January 28, 1992

Re: S/D 91-66 (Preliminary Plat) Conquest North Addition

CASE NUMBER: S/D 91-66 - CONQUEST NORTH ADDITION

FINAL PLAT CONQUEST NORTH ADDITION

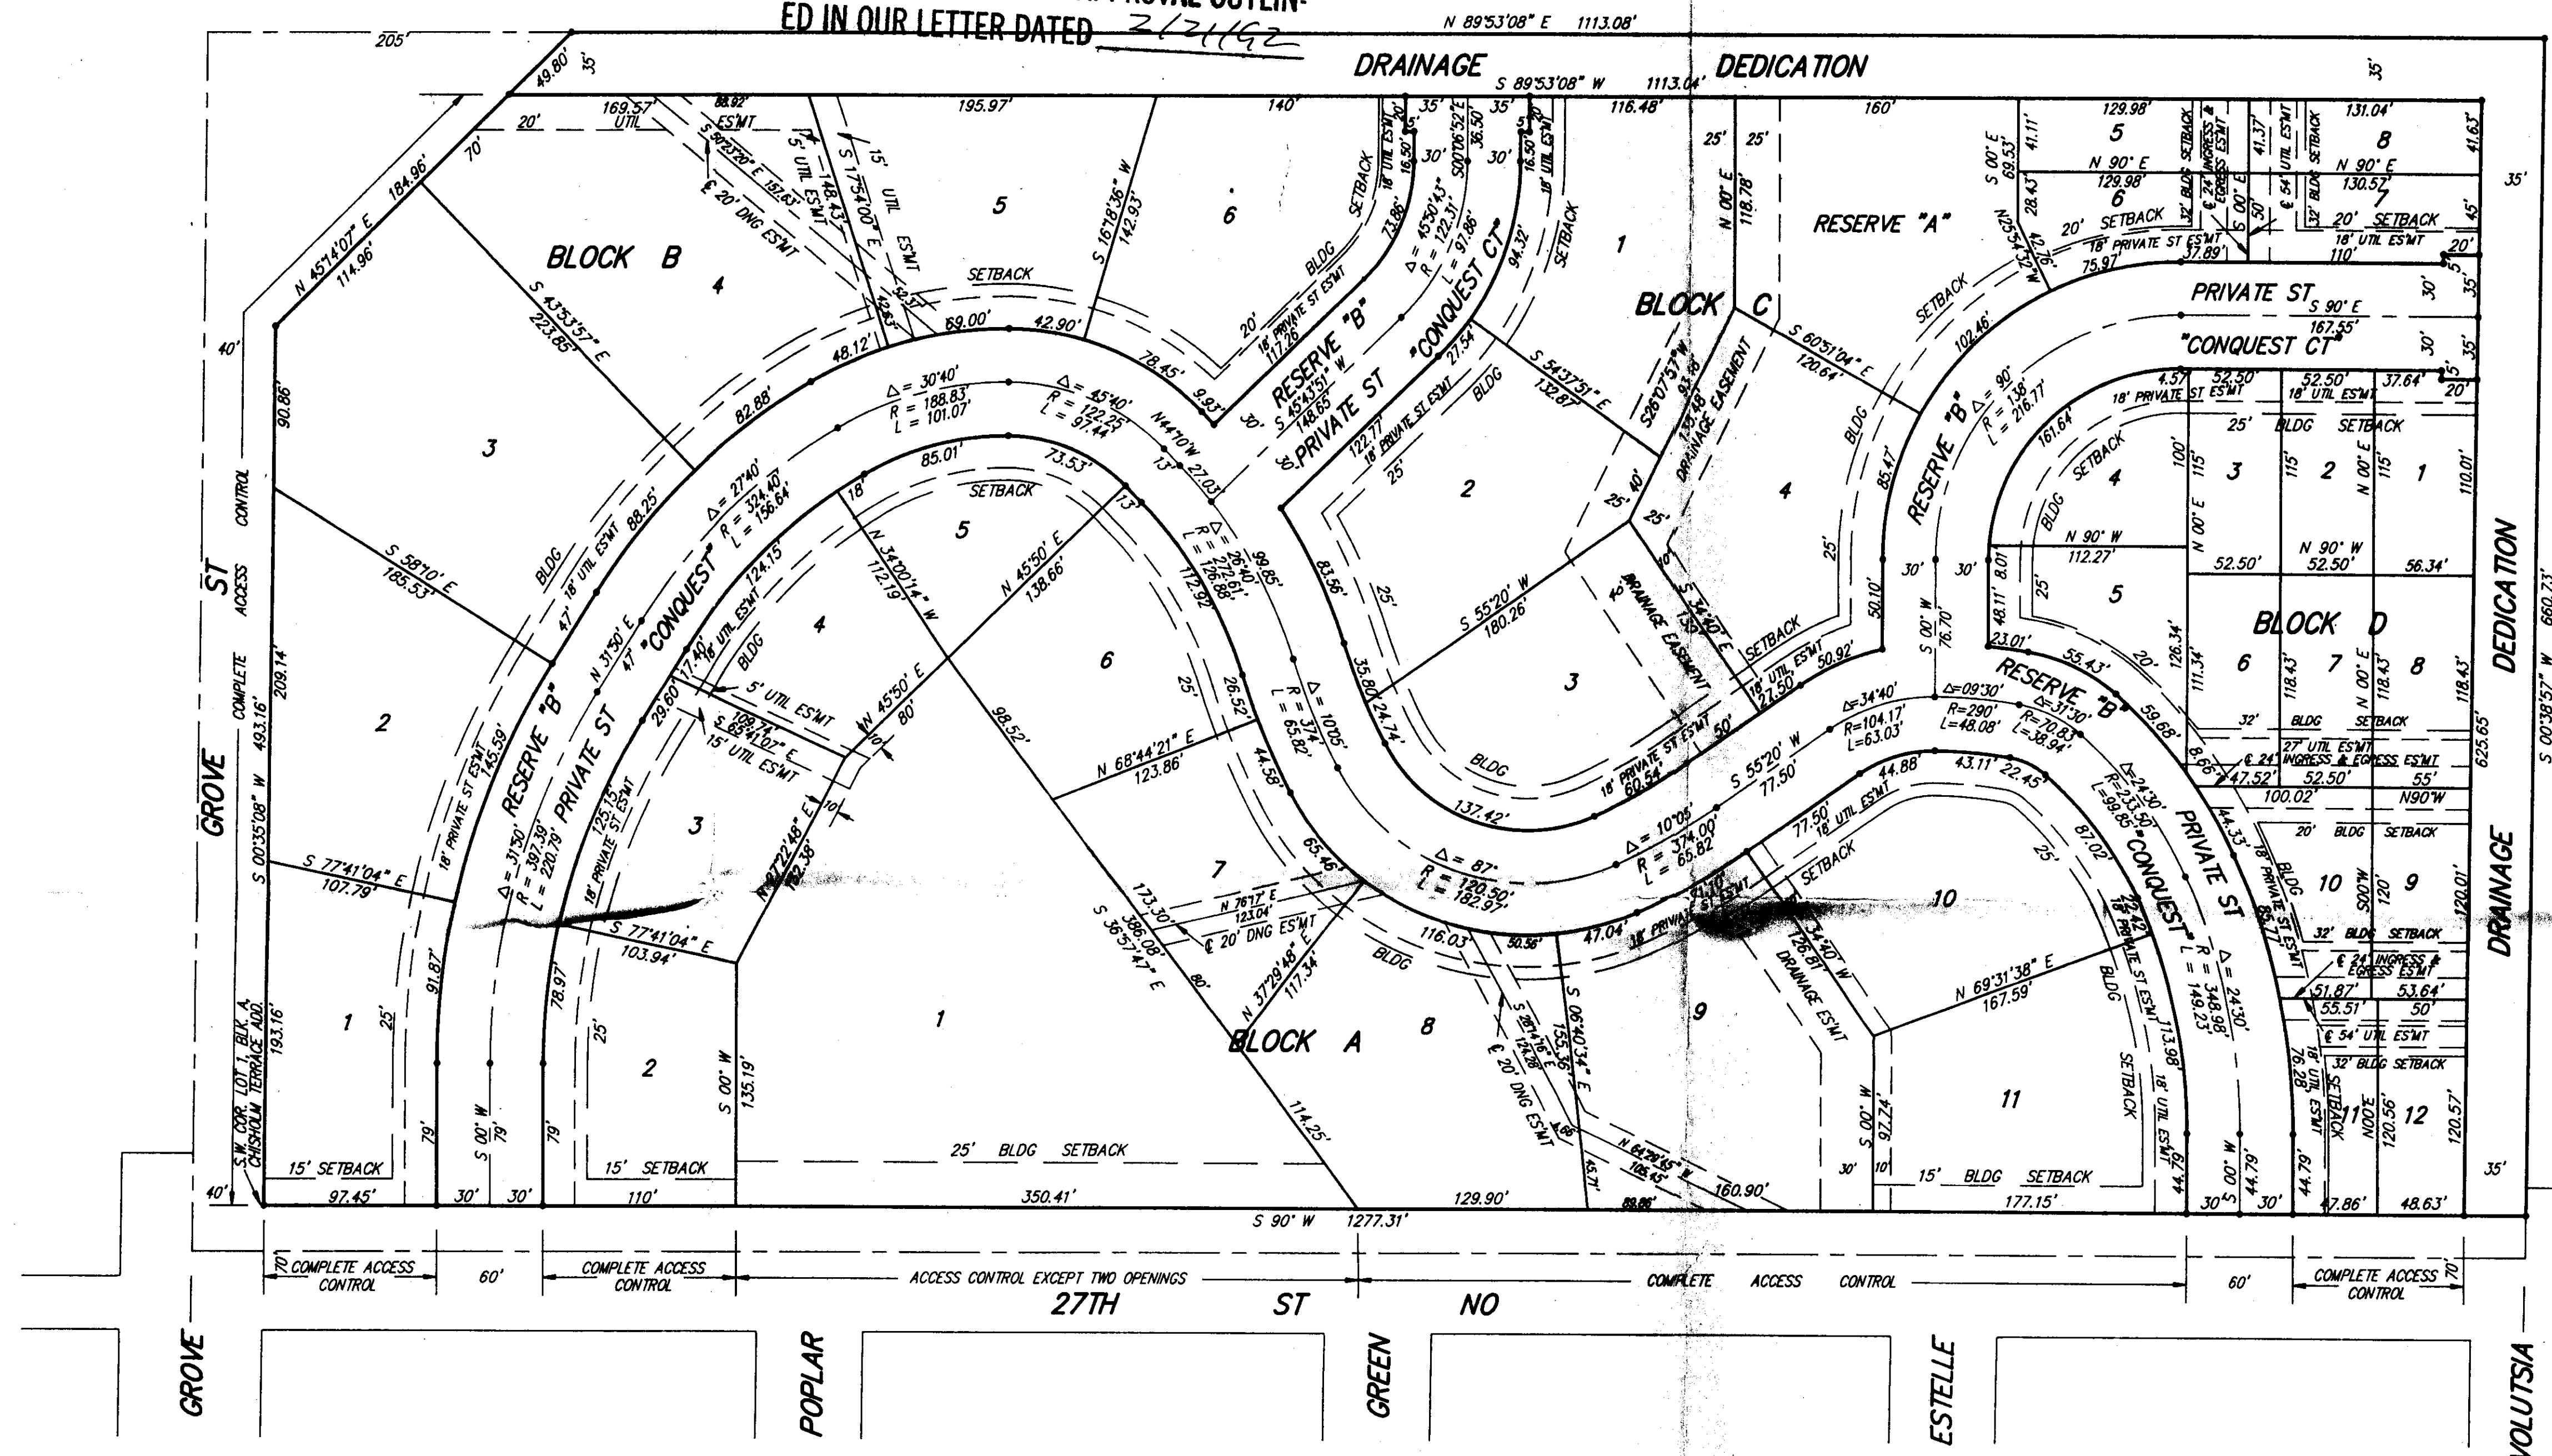
- L. Since lots 8 and 9, Block A involve double frontage with access intended from Conquest St., the final plat shall indicate complete access control across these lots' south lines to 27th St. North. Similarly, complete access control to Grove St. shall be indicated across the west line of lots 1, 2, and 3, Block B.

indicated on the plat. For the narrow lots in the eastern portion of this site, the platting of side yard setbacks seems to be an unnecessary restriction and may be deleted.

- R. On the final plat, in order to better locate the easements crossing lot 4, Block B and lots 8, and 9 Block A dimensions shall be shown from lot carriers to the easements.
